PRELIMINARY STUDY OF PROPOSED ALTERNATES FOR FLOOD CONTROL ON THE SALT RIVER BETWEEN HOHOKAM EXPRESSWAY AND MARICOPA FREEWAY

Prepared By:
ROYDEN ENGINEERING CO.
2846 West Weldon
Phoenix, Arizona 85017
January, 1979

Attached is an Addendum to the Report on Alternates to Salt River Channelization between Hohokam and Maricopa Freeway Bridge. The Report is dated January, 1979.

Revised: January 25, 1979

ALTERNATE #1

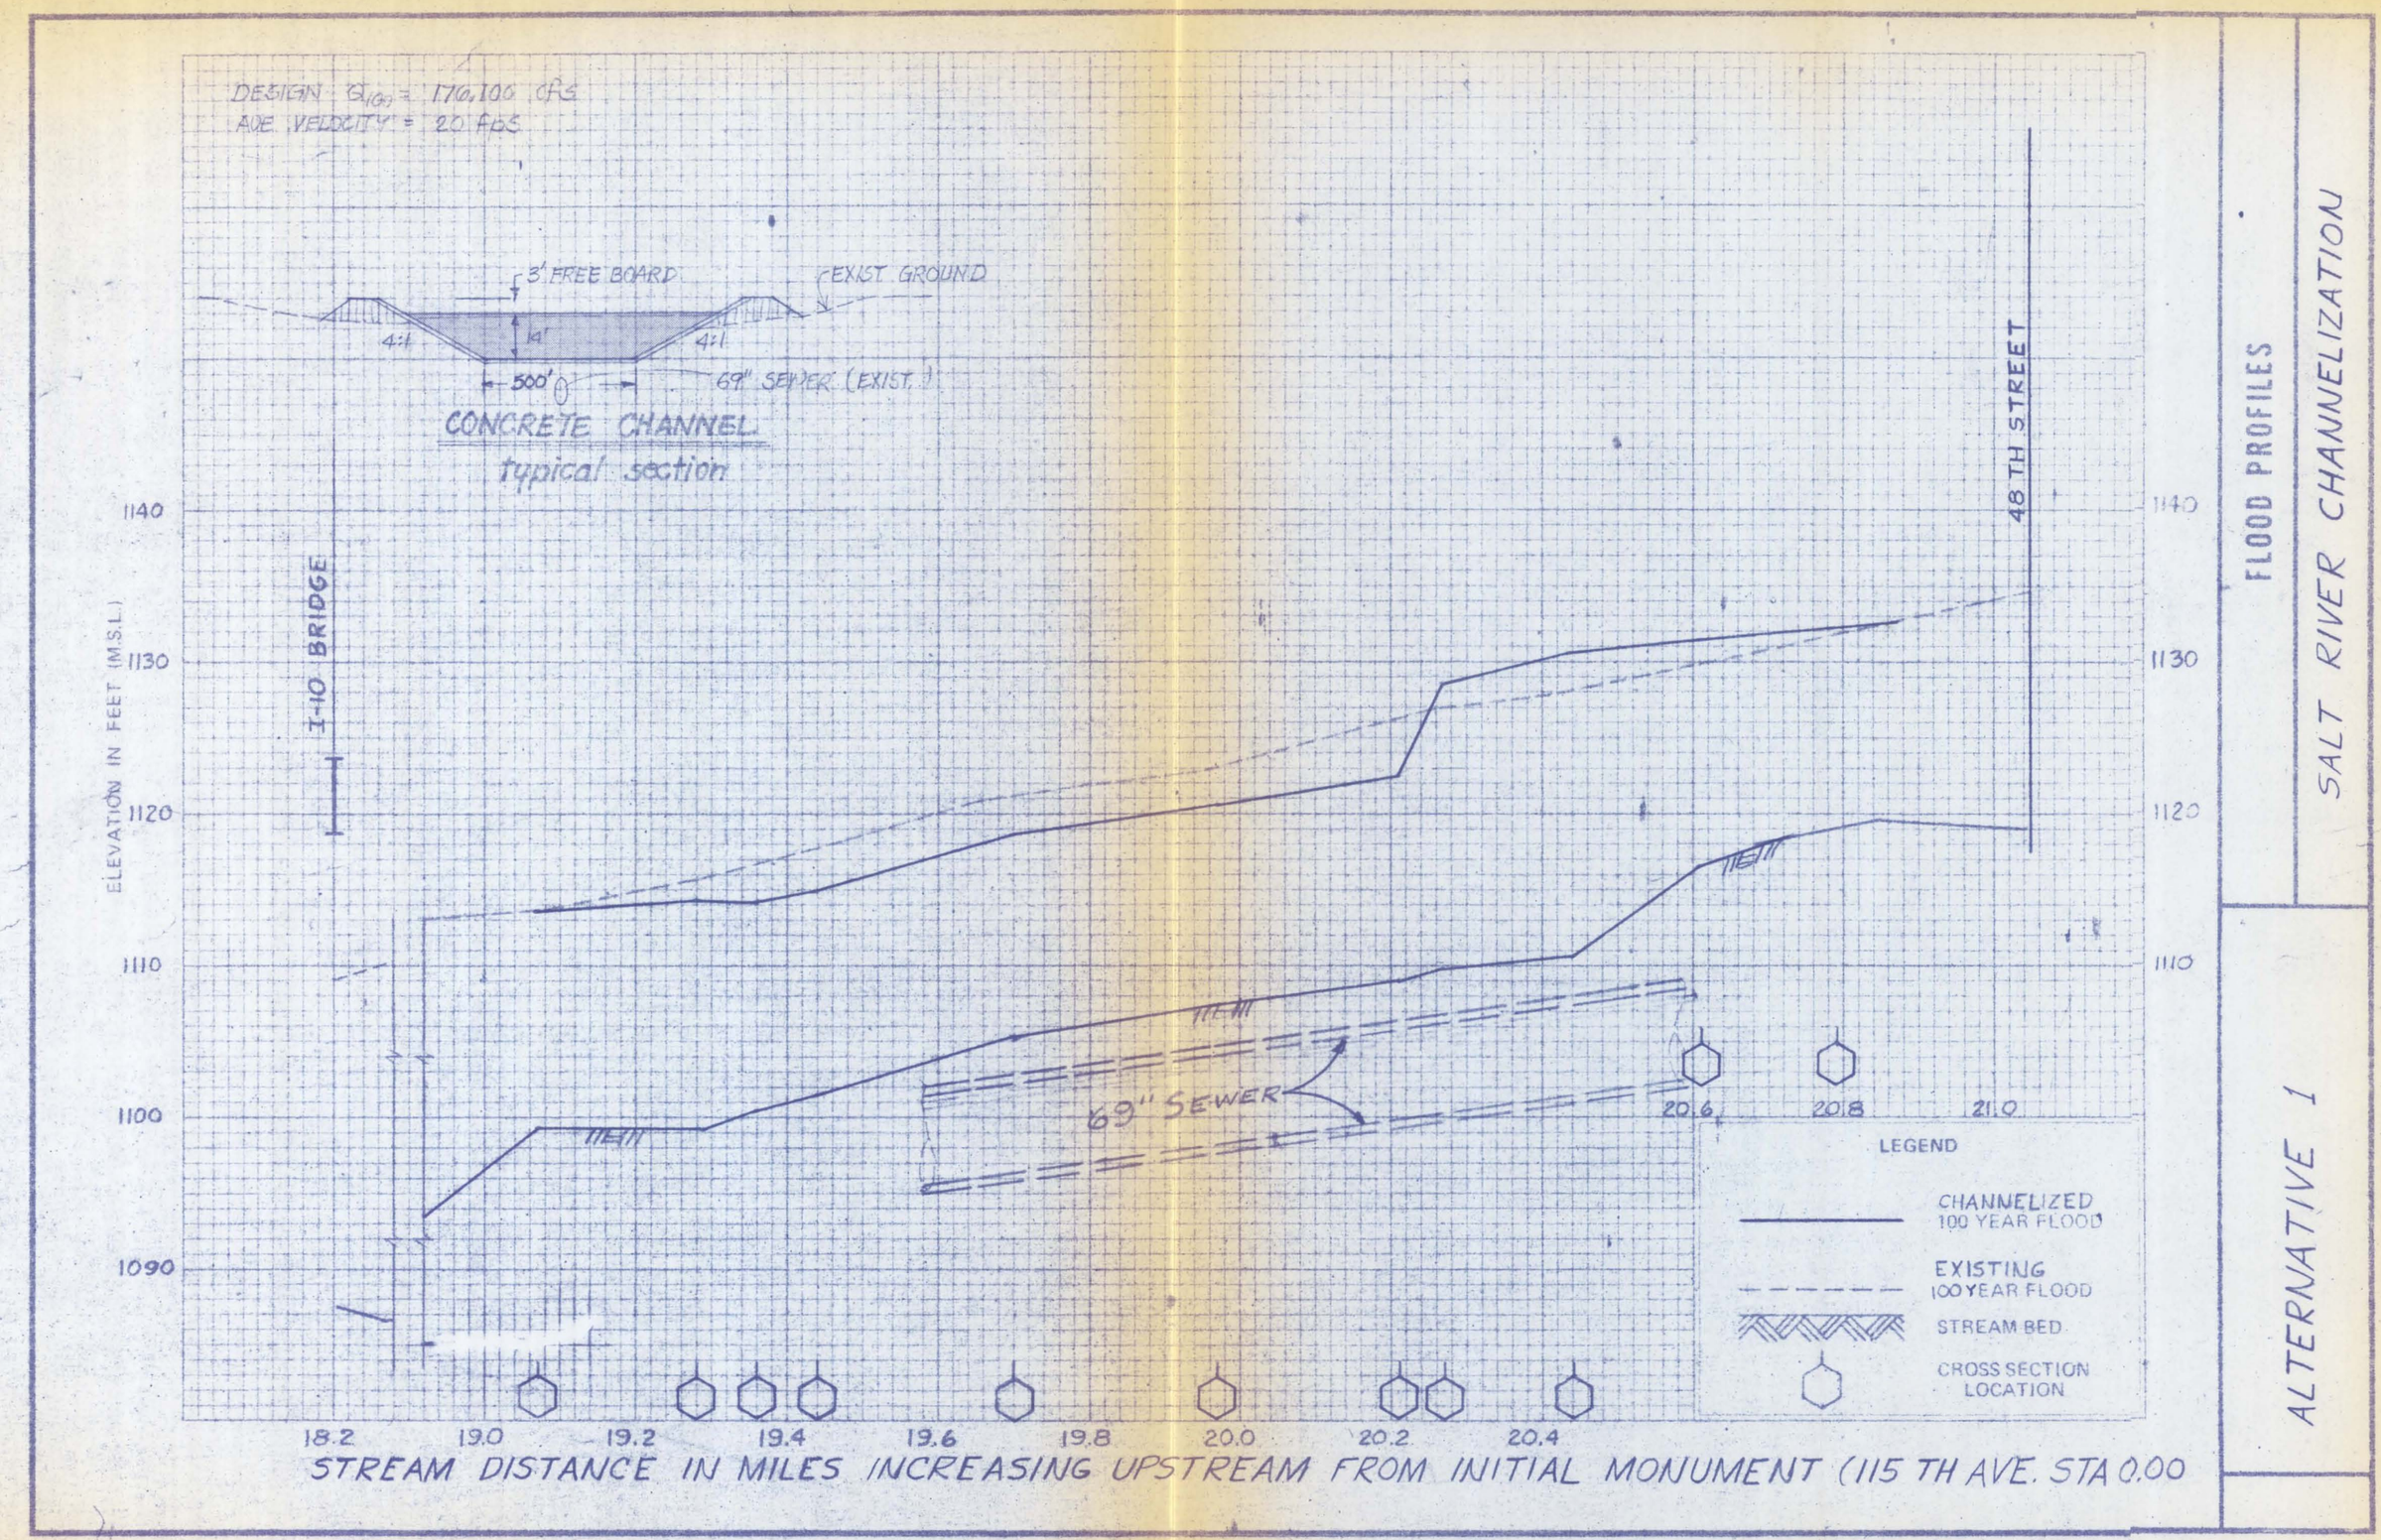
An additional Alternate No. 3 A is reviewed. In addition, the Cost Estimate for Alternate No. One is based on a 500' wide channel while the profile and high water elevations are based on a 600' wide channel. The 500' wide channel analysis is based on a lower flow line than the 600' width. The 500' width channel is therefore a workable solution; however, the 69" sewer line would have to be relocated or protected. If the 500' channel is set to the same grade as the 600', the water surface profile would be 2 - 3' above the "before" condition. This could be taken care of with slightly higher levees in this area; however, additional study of results of higher levees should be made to check the affects on surrounding areas.

In summary, an additional figure of $800,000 should be added to the Alternate No. 1 price for relocating or protecting the sewer or 1.8 million should be added for a 600' wide channel.

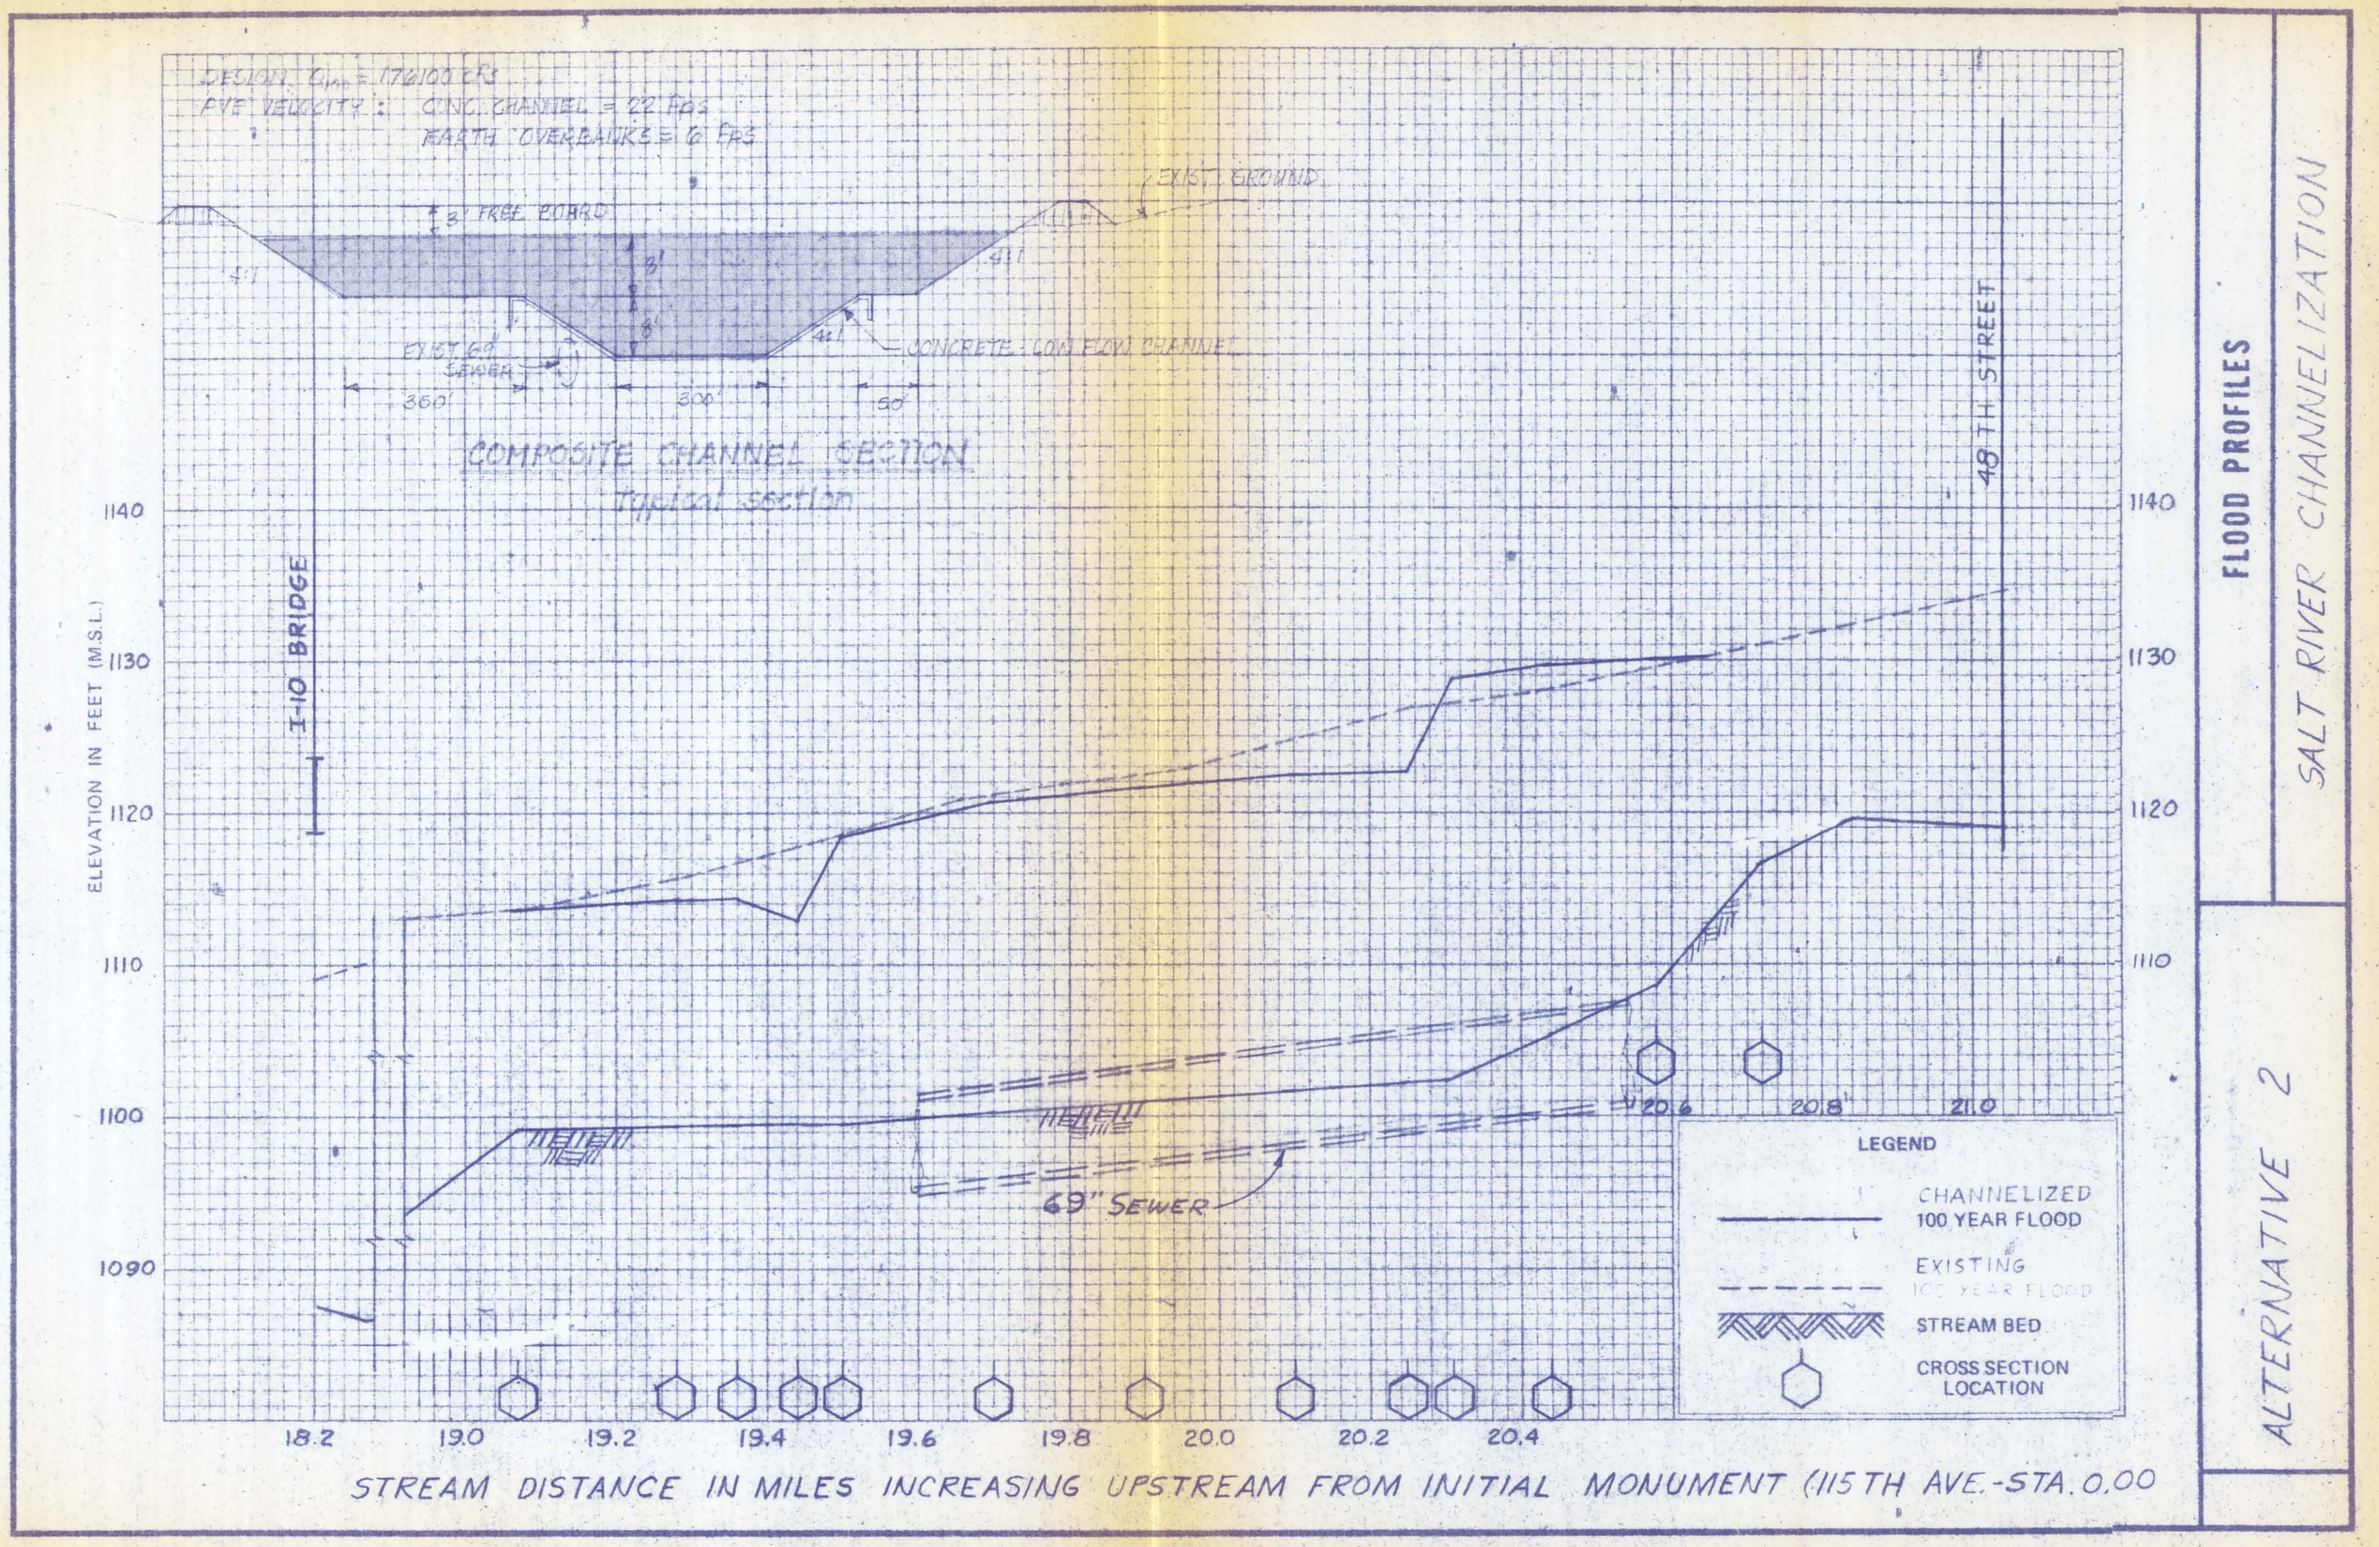
Page 10 of the report which describes Alternate No. 2 should be altered to state that the low flow channel would provide for 30-40,000 cfs as velocities would be reduced as depth of flow decreases.

This alternate provides for a combination low flow channel of concrete with side channels of earth. The low flow channel would provide for ~~40 - 50,000~~ 30,000 cfs depending on the final configuration selected and the outer channel would provide again for the 100 year storm flow of 176,100 cfs. The alternate would be located such that the 69" sewer line would be to the side of the concrete or low flow channel and as such would not present a conflict problem with the grade of the low flow channel. Sizing of the channel would again be such that the design high water would be below that of the HUD-FIA study. Preliminary channel size analyzed was 300' wide low flow channel with 3:1 side slopes and an overall channel width of 800' with protected side slopes. Protection of the side slopes would be with wire basket type rip-rap anchored to the slopes or with concrete paved slopes. Depth of flow in the earth portion of the channel would be eight feet.

EARTH CHANNEL
ALTERNATIVE 3A

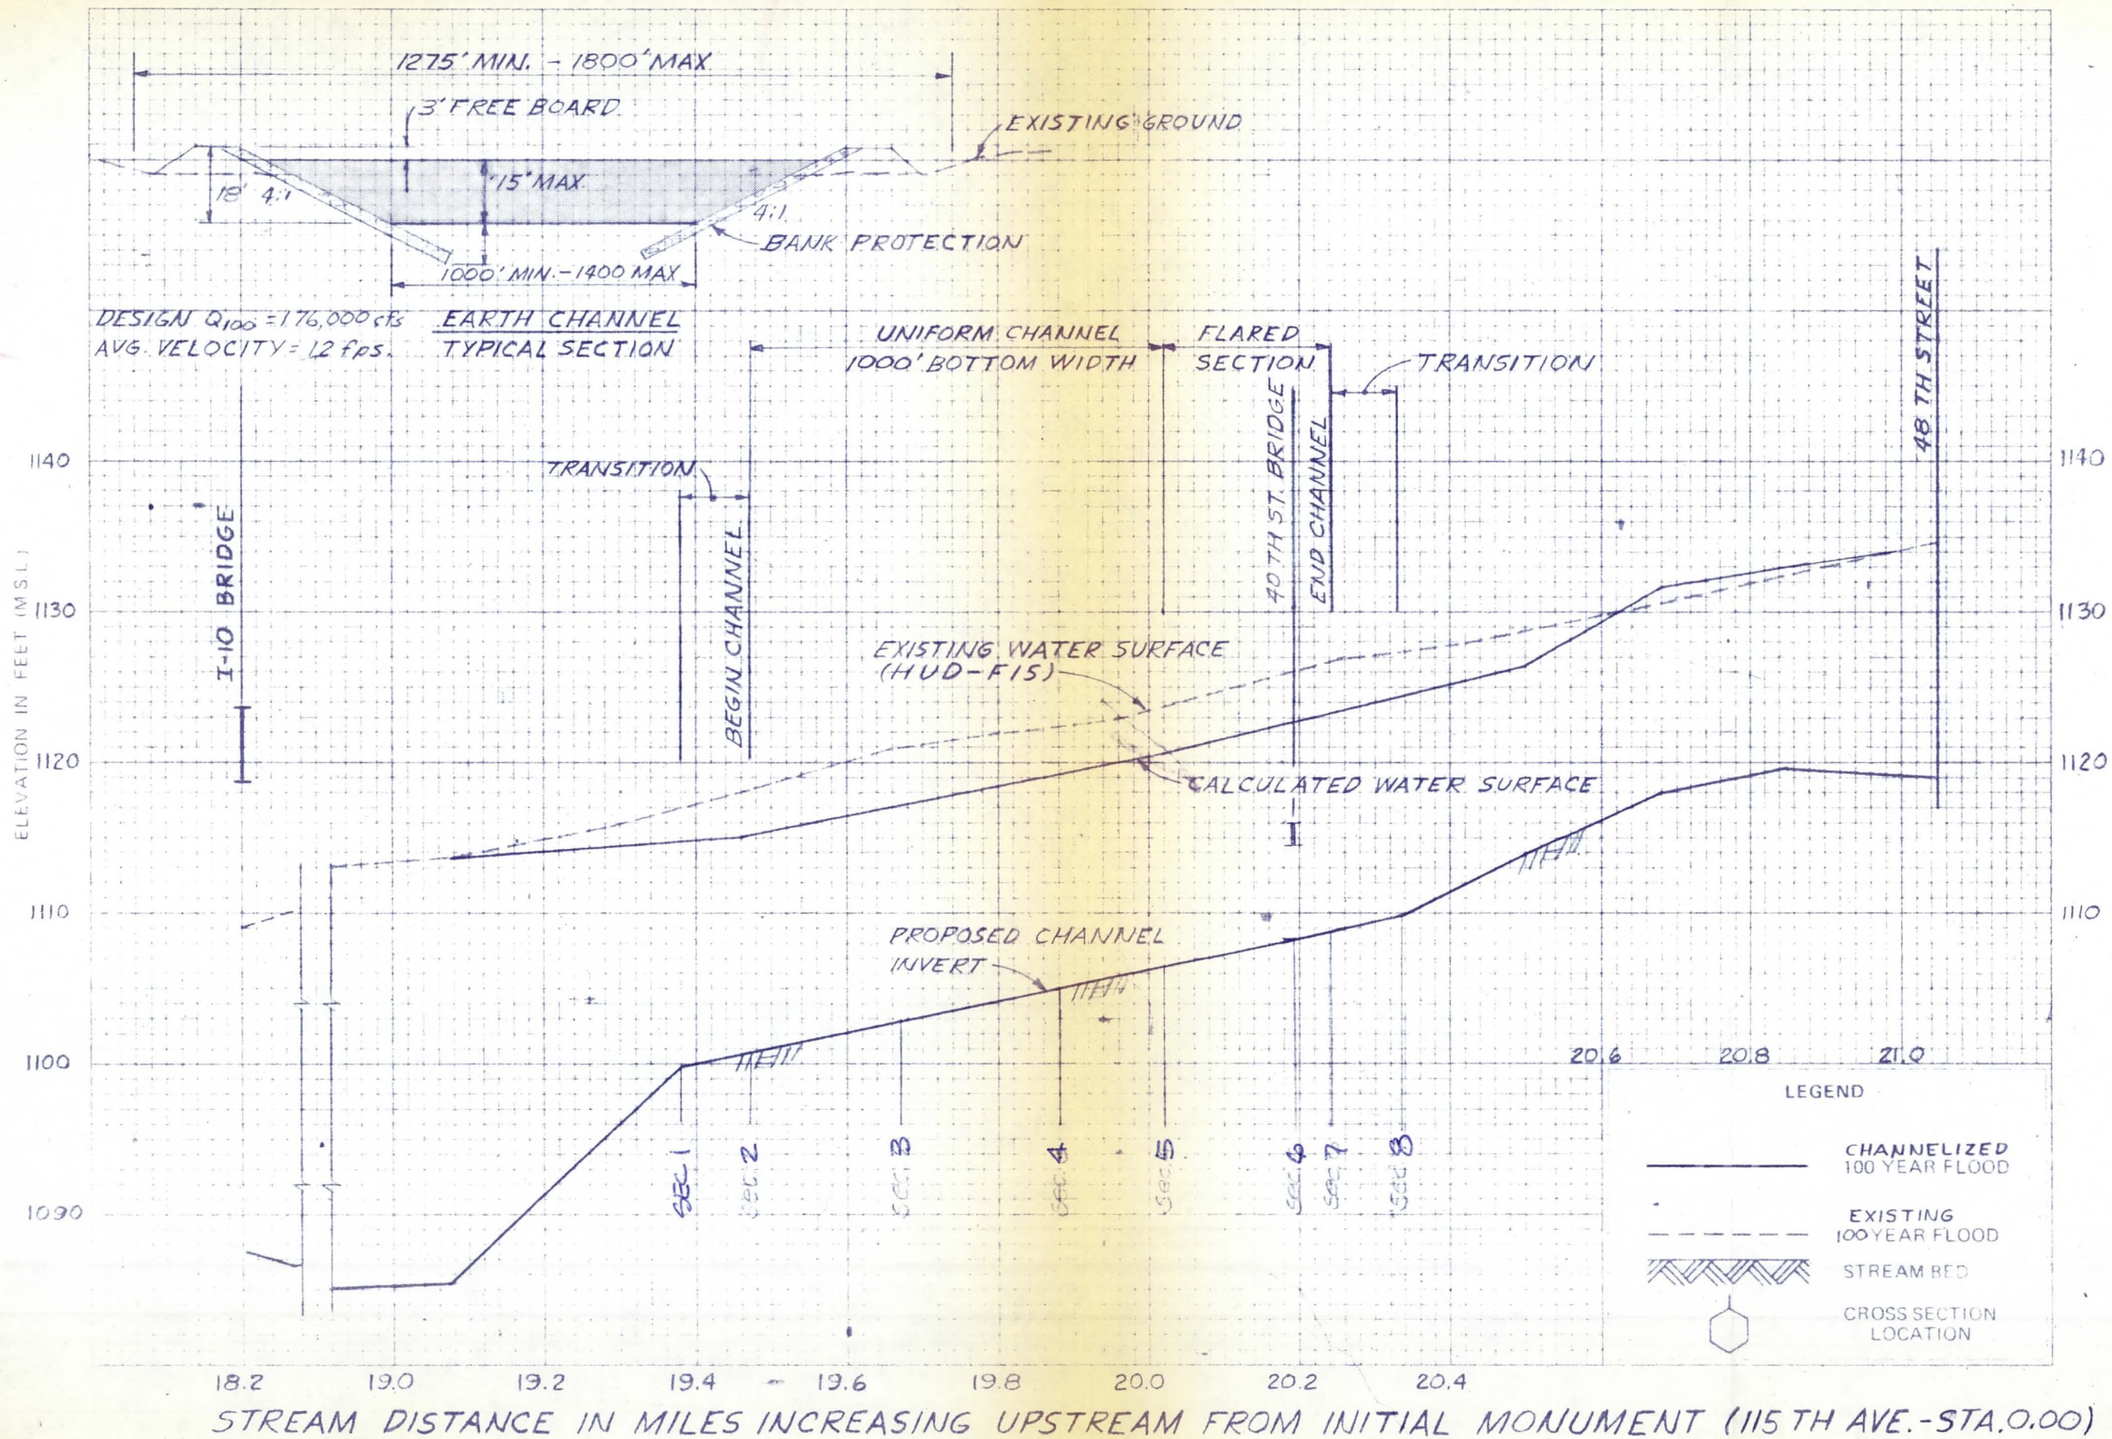
ALTERNATE NO. 3A

This alternate is a modification of Alternate No. 3. The same 1,000 foot channel is utilized but the alignment is moved to the south to allow for more of the runway to be replaced outside of the channel area.

It also provides for a variable width channel to accommodate the existing 40th Street bridge. The bridge would be allowed to remain in place and would act as a low flow bridge for 15,000 $\pm$ cfs. Temporary wing dikes upstream and downstream of the bridge would serve to direct flows through the structure during periods of extended low releases from the Salt River Project Dams. Fortieth Street roadbed would be aligned along the top of the south dike for some distance and then drop into the channel to cross at approximately channel grade.
